ADA Curb Ramp New Construction Inspection Form (Parallel)

Main	24952.54			Commercial
North-South Road Name	Project No.	Sheet No.	Intersection No.	East-West Road Name
Calibration Date 10/8/2024 (mm/dd/yy)

PARALLEL RAMP (PL)

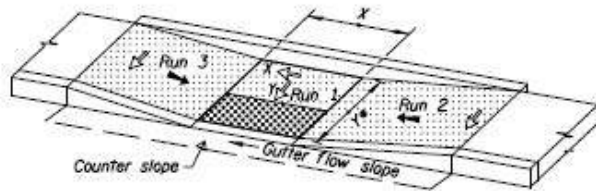
Stop sign in rr2. IITD gt2. Water meters in rr2 and turn space. Crack in rr2.
